HUNTS POINT INTERSTATE ACCESS IMPROVEMENT PROJECT – CONTRACT 3

PIN X731.65, Contract D900055

Request for Proposals

Addendum #2

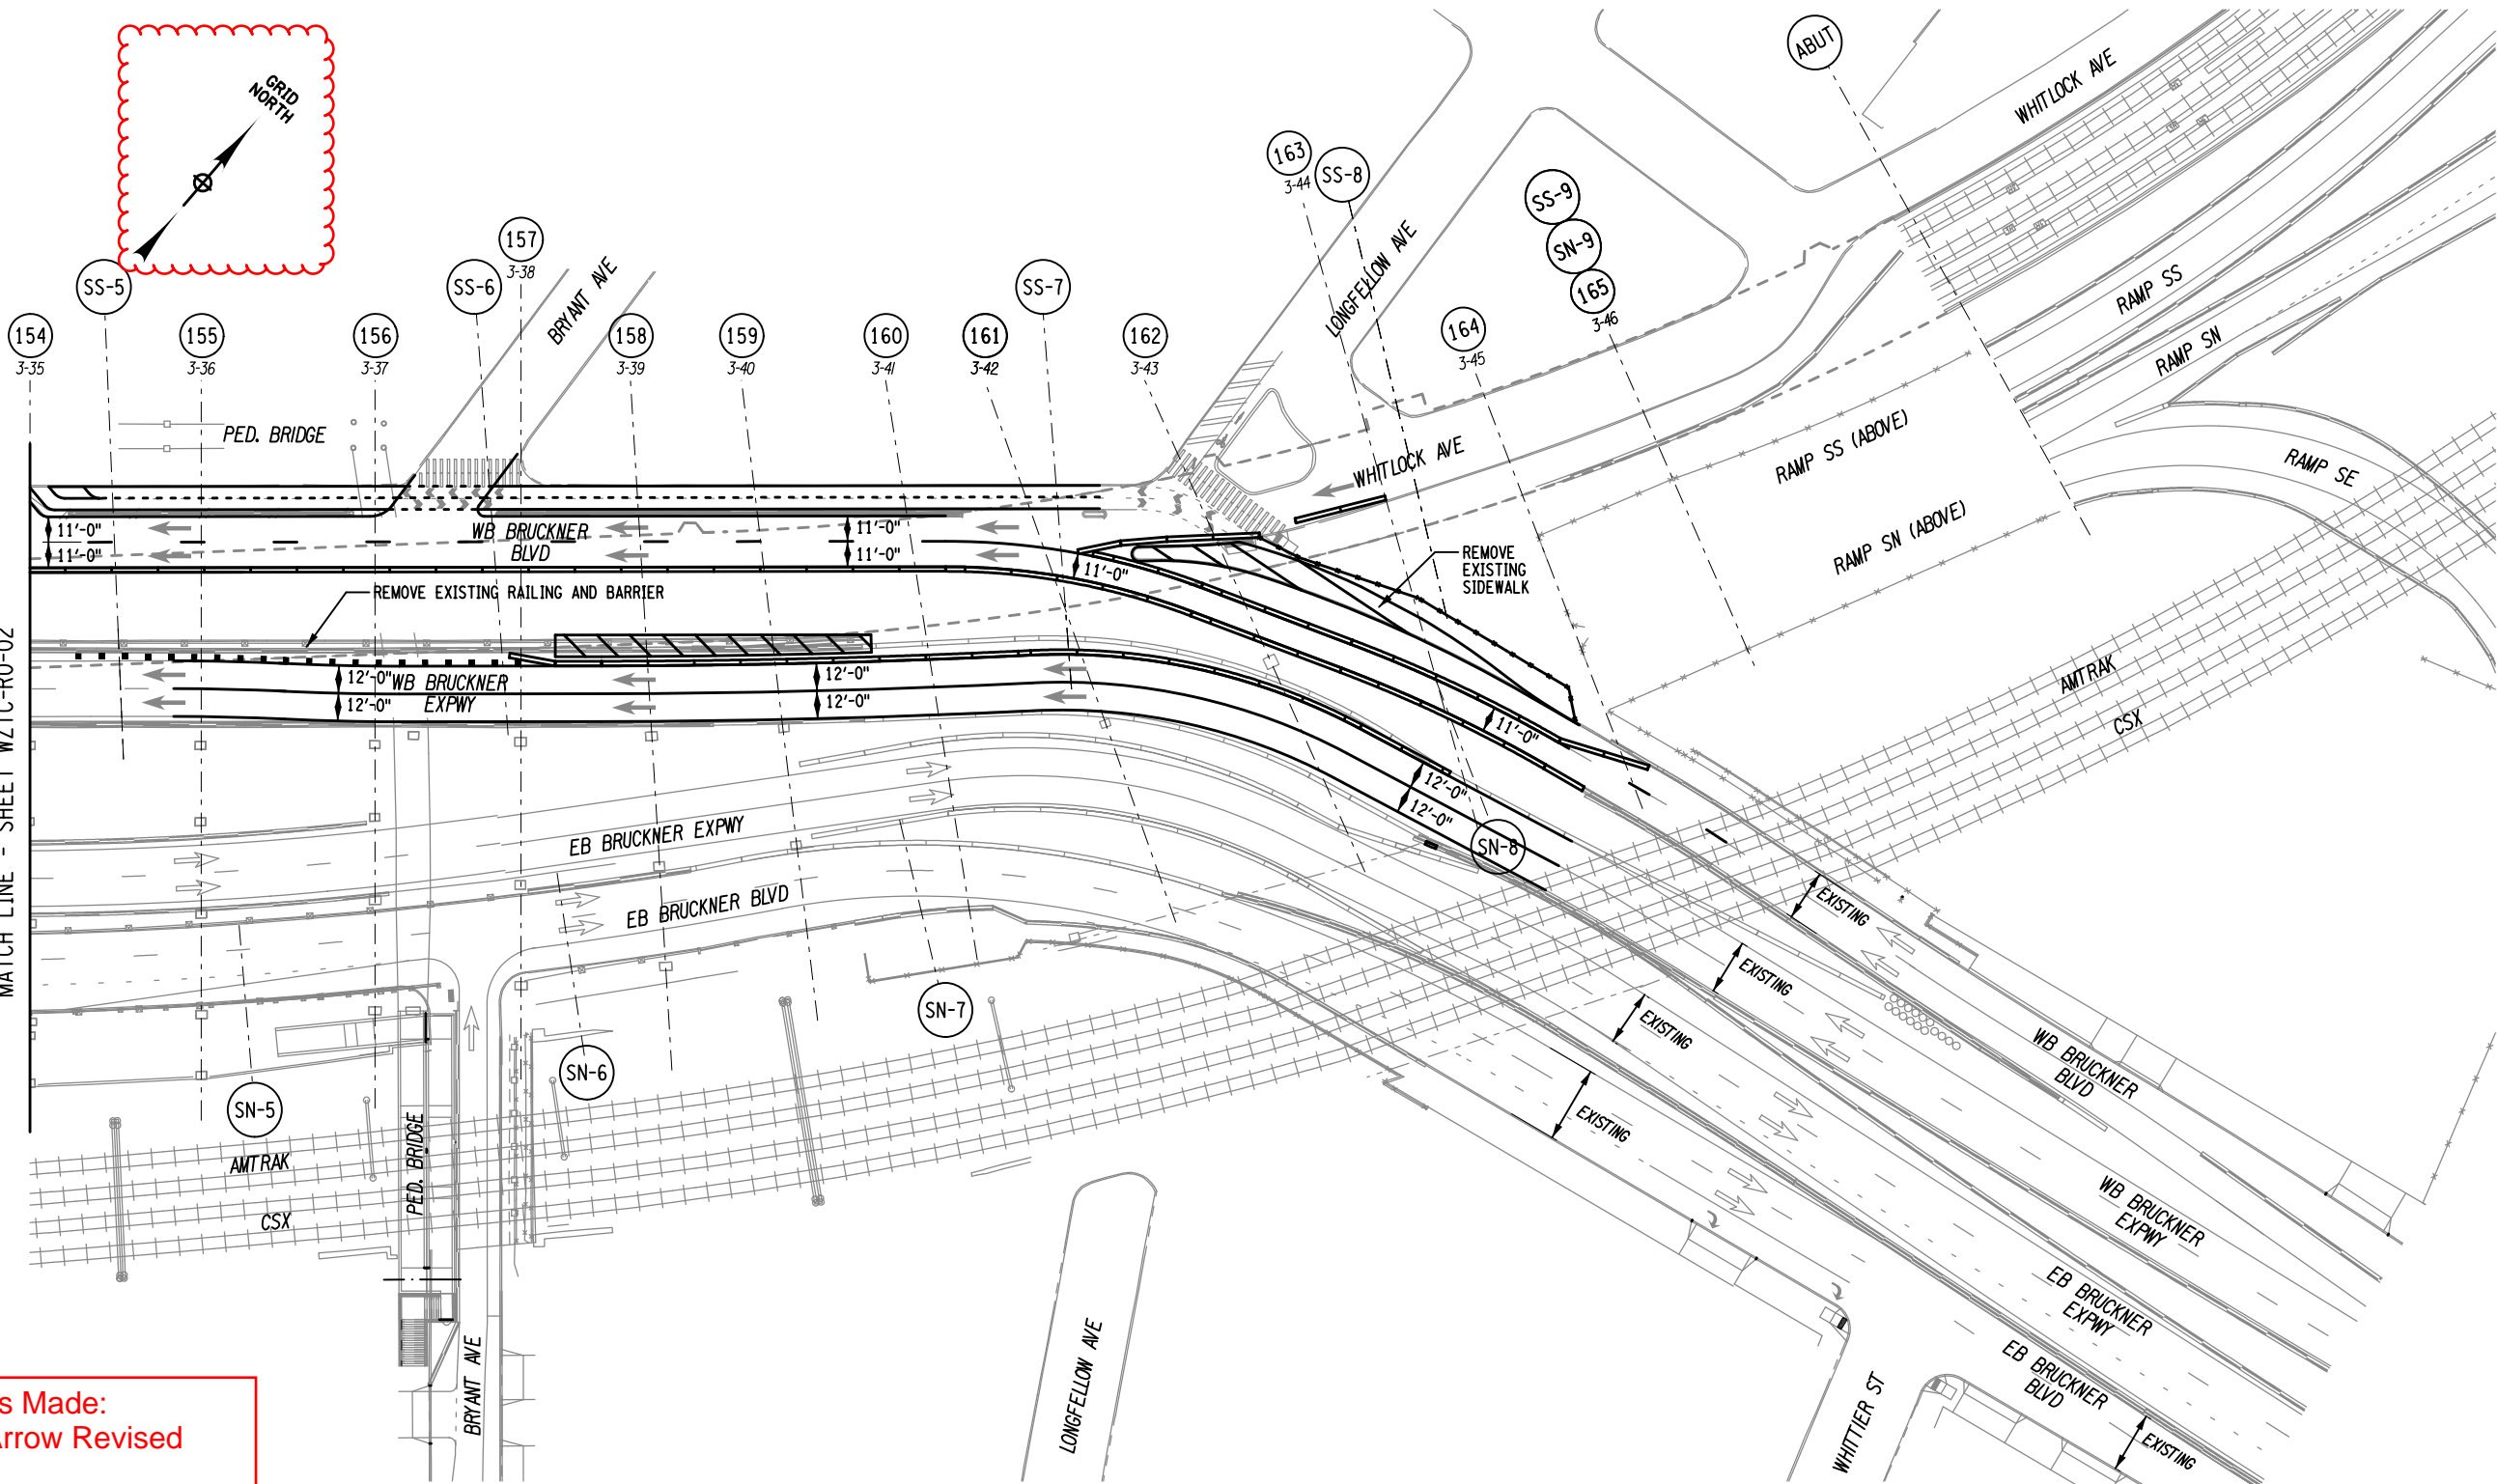
Revisions Made:
- North Arrow Revised

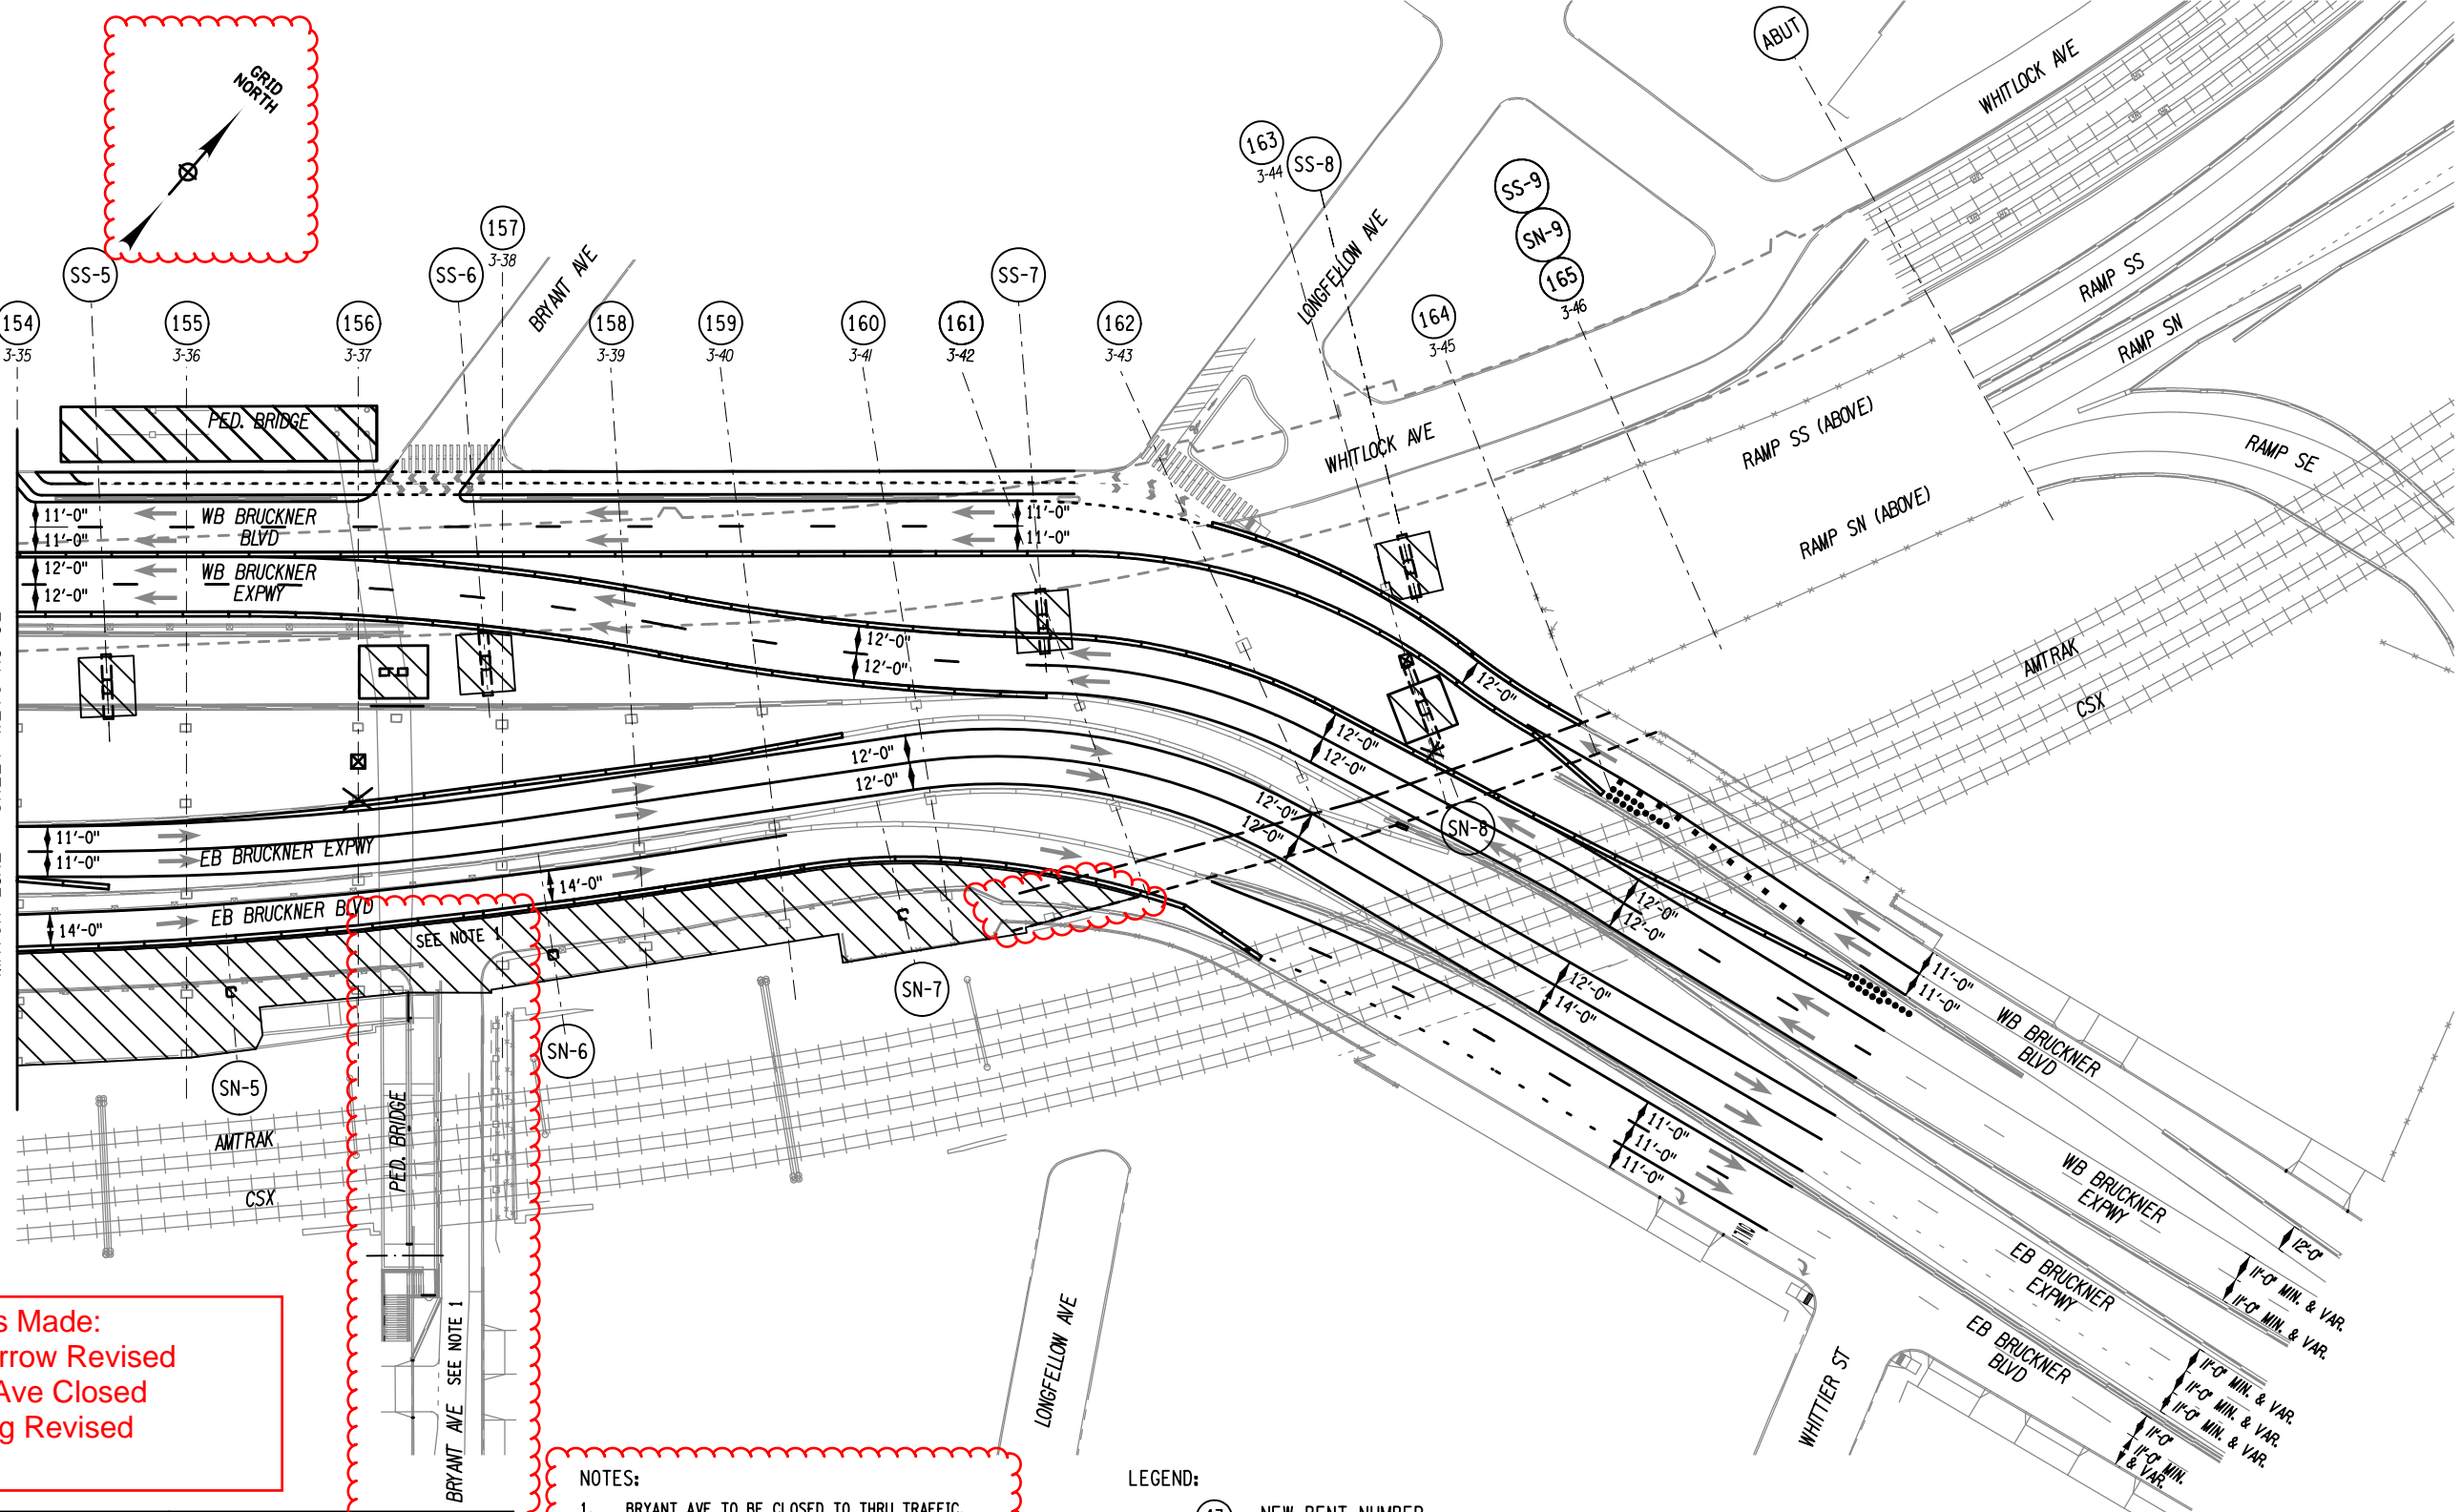
Revisions Made:
- North Arrow Revised
- Bryant Ave Closed
- Hatching Revised

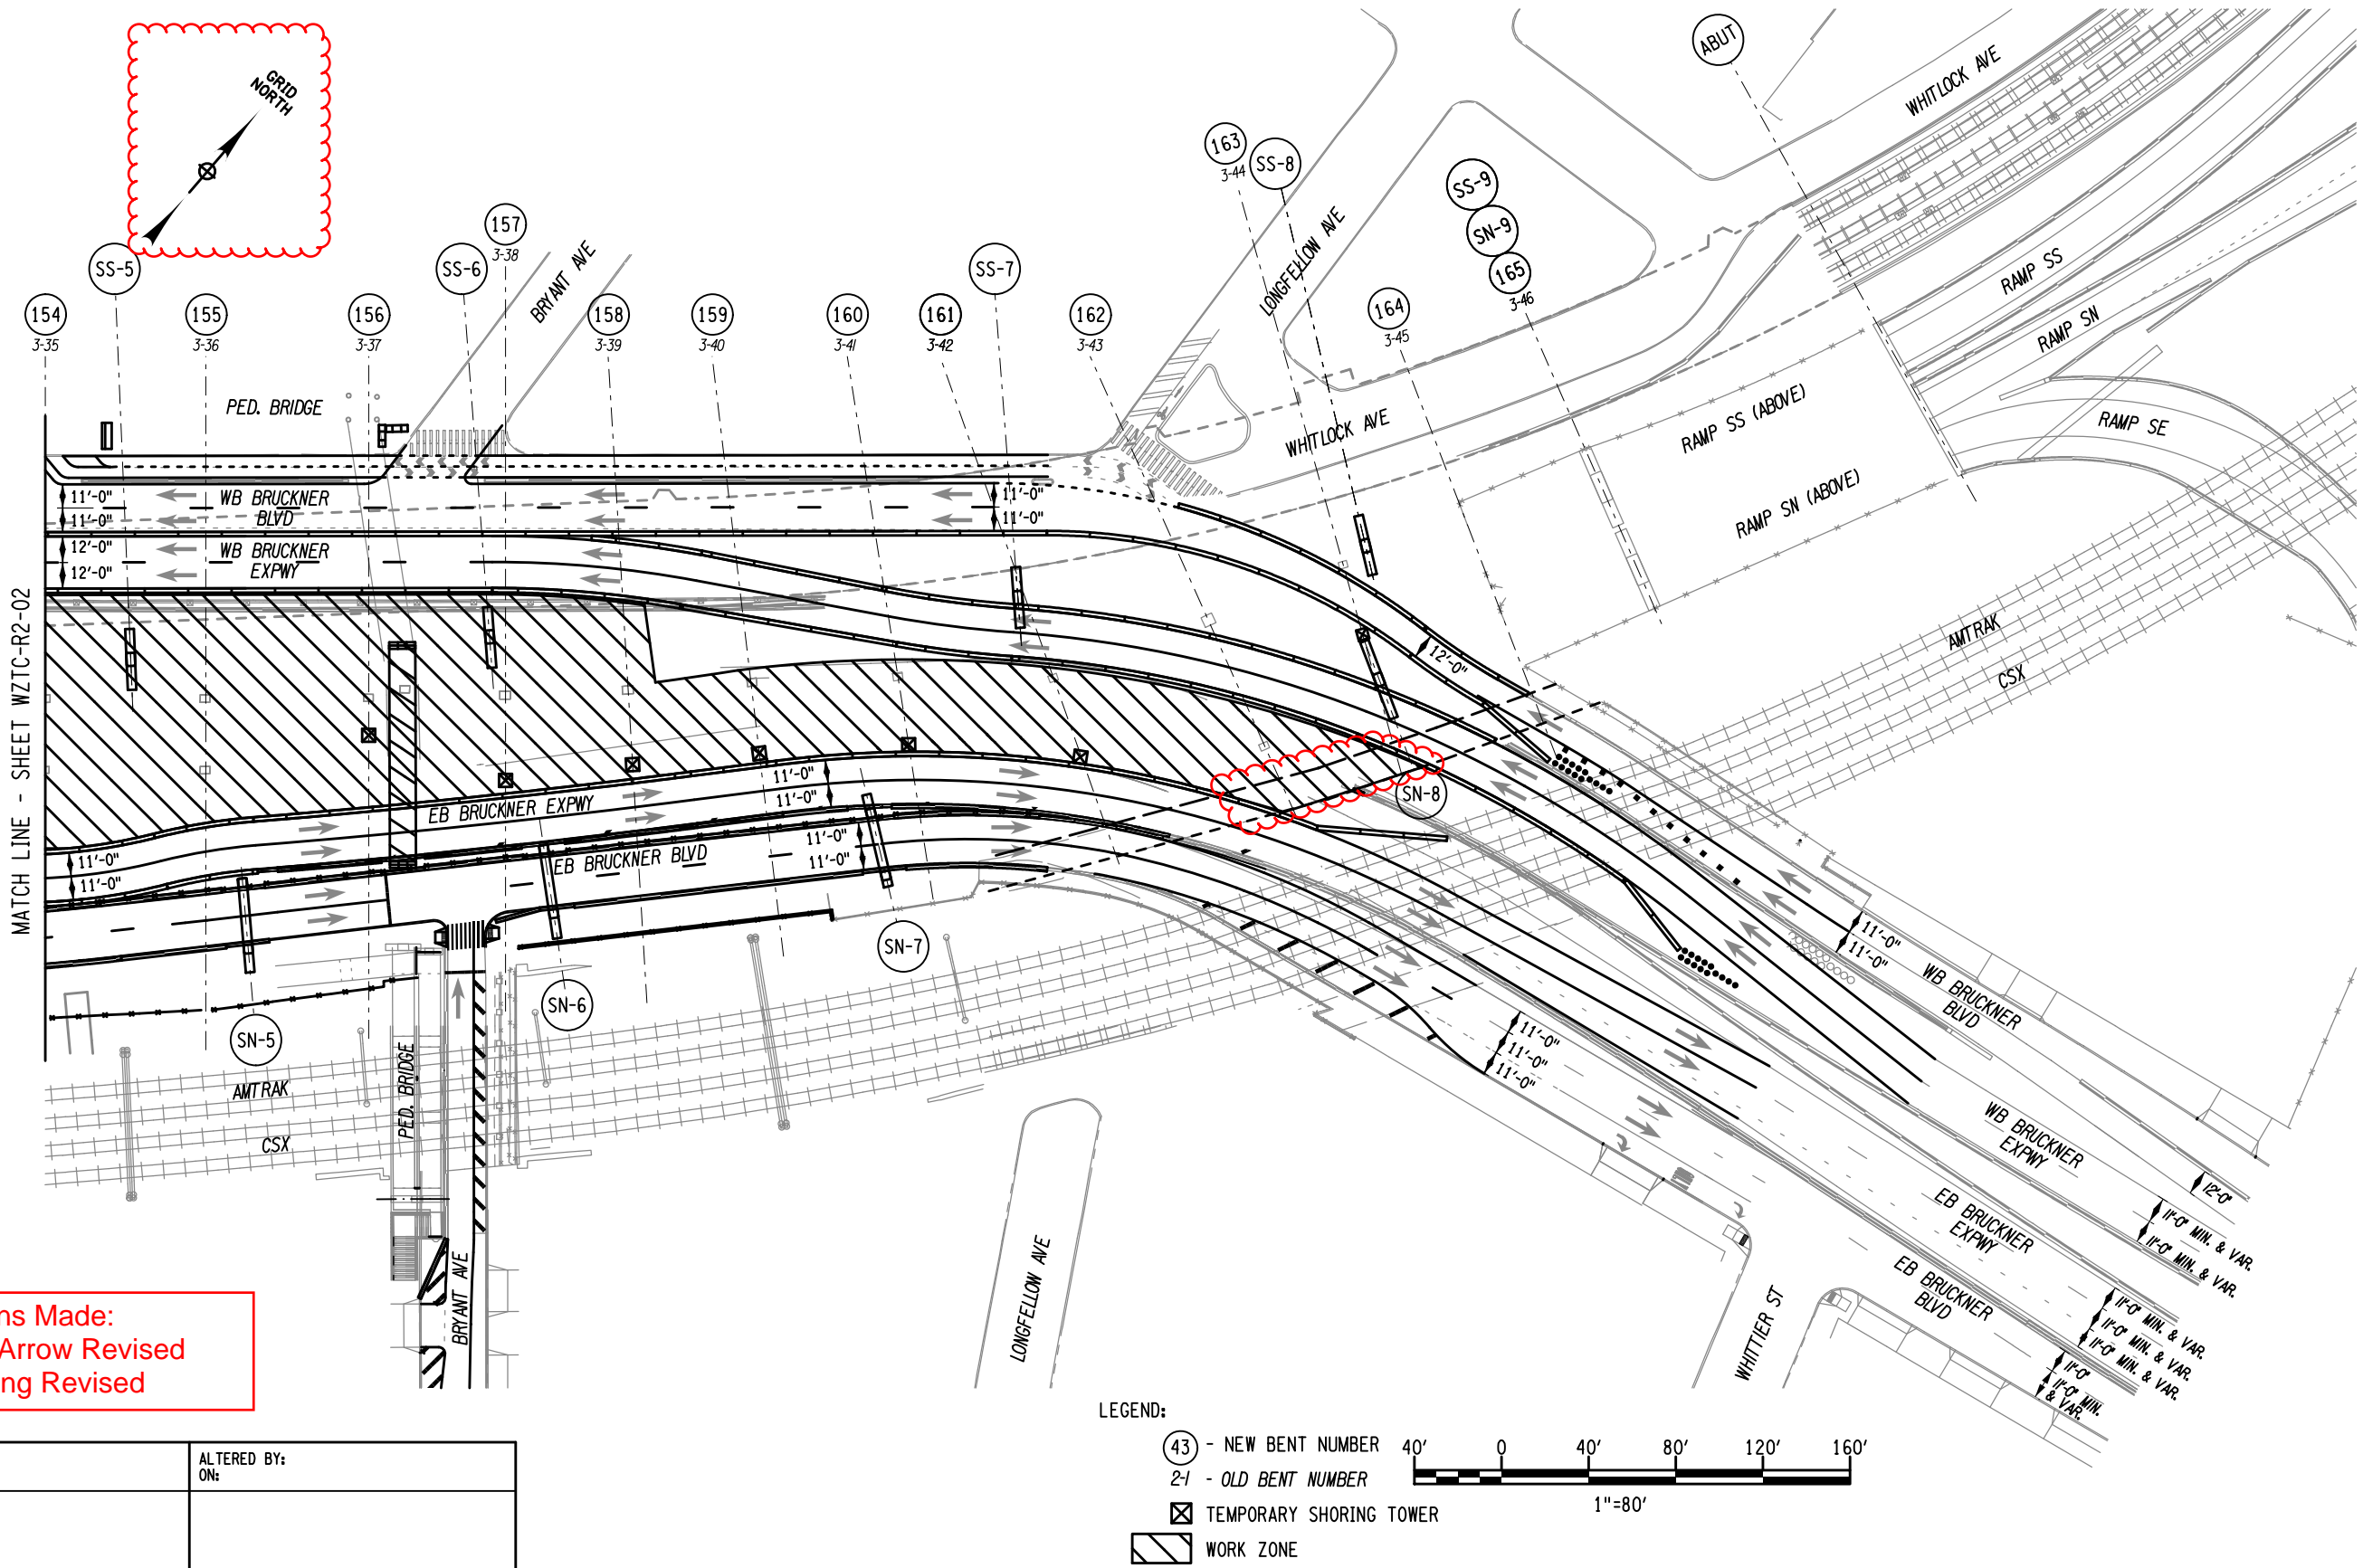
Revisions Made:
- North Arrow Revised
- Hatching Revised
